INNER WEST COUNCIL

DEVELOPMENT ASSESSMENT REPORT

Application No.	201500242
Address	2 - 8 Arthur Street, Marrickville
Proposal	To demolish existing improvements, consolidation of land into 1 allotment and construct a 7 storey residential flat building with 38 dwellings and 2 basement levels of associated car parking.
Date of Lodgement	18 May 2015
Applicant	Architects Becerra
Owner	Momentum Living Pty Ltd
Number of Submissions	5 including a petition containing 117 signatures
Value of works	\$8,054,382
Reason for determination at Planning Panel	The extent of departure from the building height and FSR development standards exceed staff delegation.
Main Issues	<ul style="list-style-type: none"> • Clause 4.6 variations for building height and FSR
Recommendation	Approval, subject to conditions

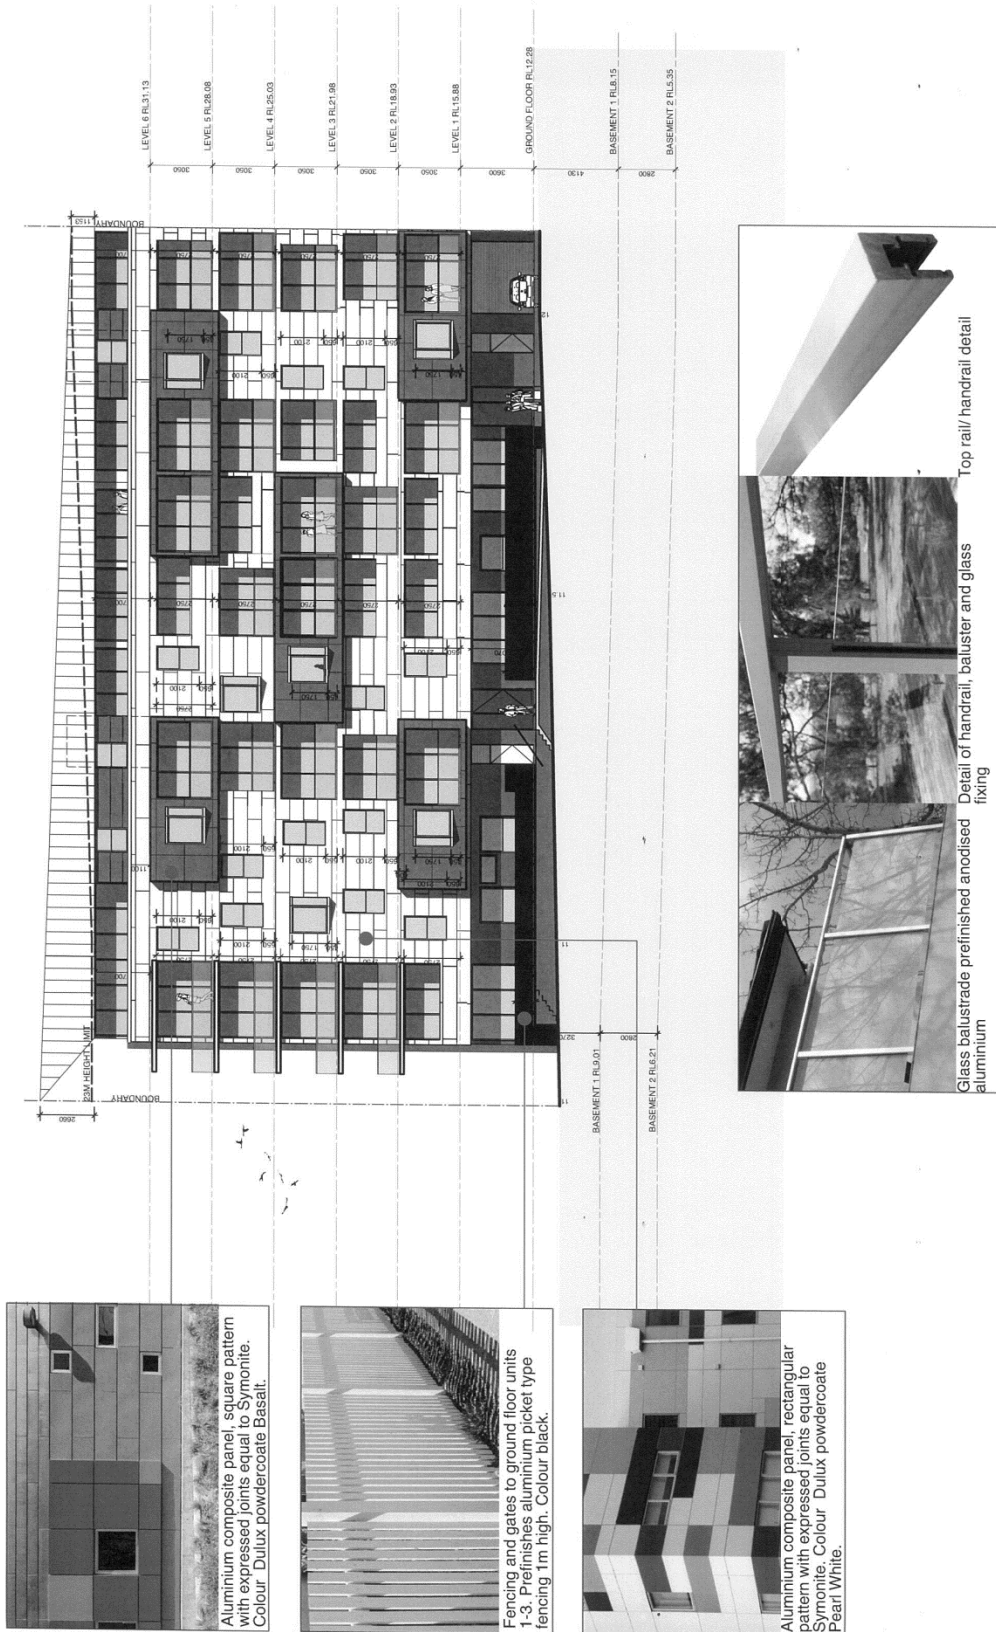
- Recommendation 1: *The North Elevation illustrated on dwg n° A13 should be amended to delete the 1.2m to 1.8m high solid wall to the ramp so that the drawing is consistent with the public/private interface proposed on dwg n° A22.*

SECTION 2 & PART NORTH ELEVATION

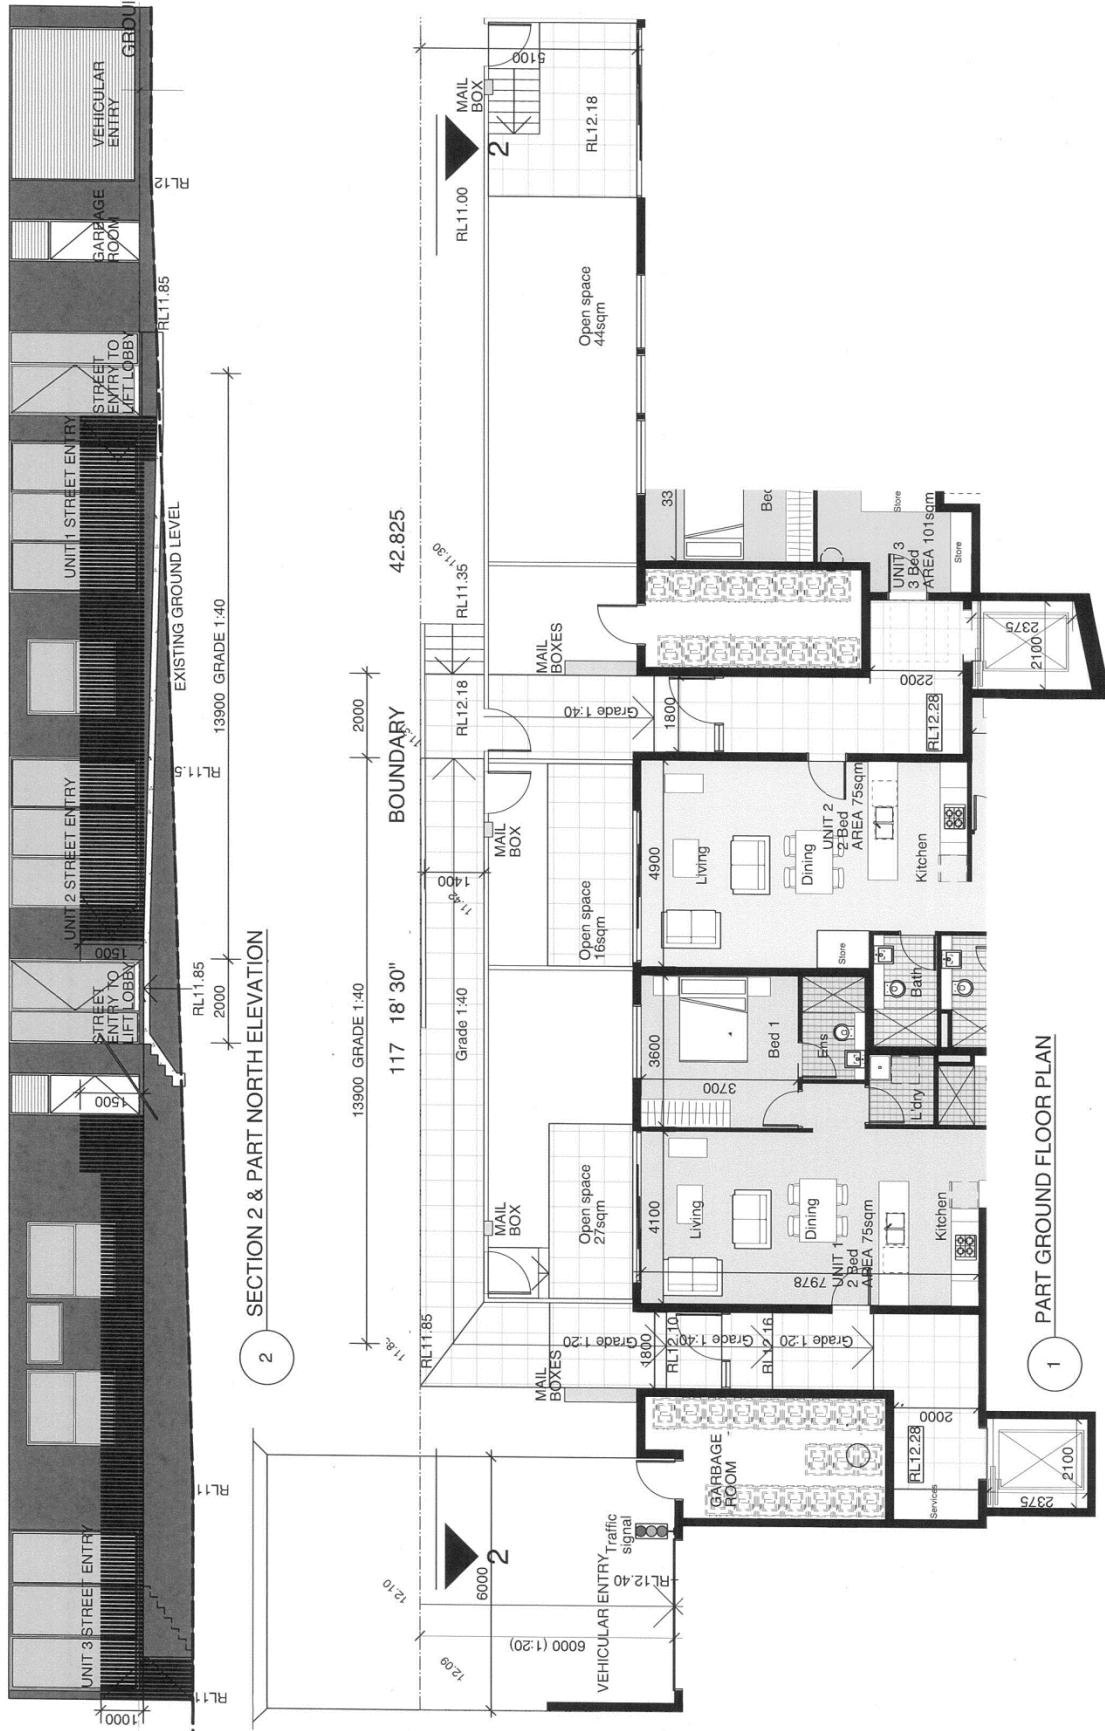
3. **North Elevation (Arthur St Façade):** *the proposed interface between the Ground Floor units and the street is clearly illustrated on the detail Ground Floor Plan and North Elevation (dwg n° A22) and is supported. Front fencing height varies from 1.0m to 1.5m and are semi-transparent, providing enough privacy to the courtyards whilst ensuring opportunities for passive surveillance. The level change between the units and the footpath, with the RL of units approximately 0.5m to 1.0m higher than the RL of the footpath, will provide good demarcation between public and private realms.*
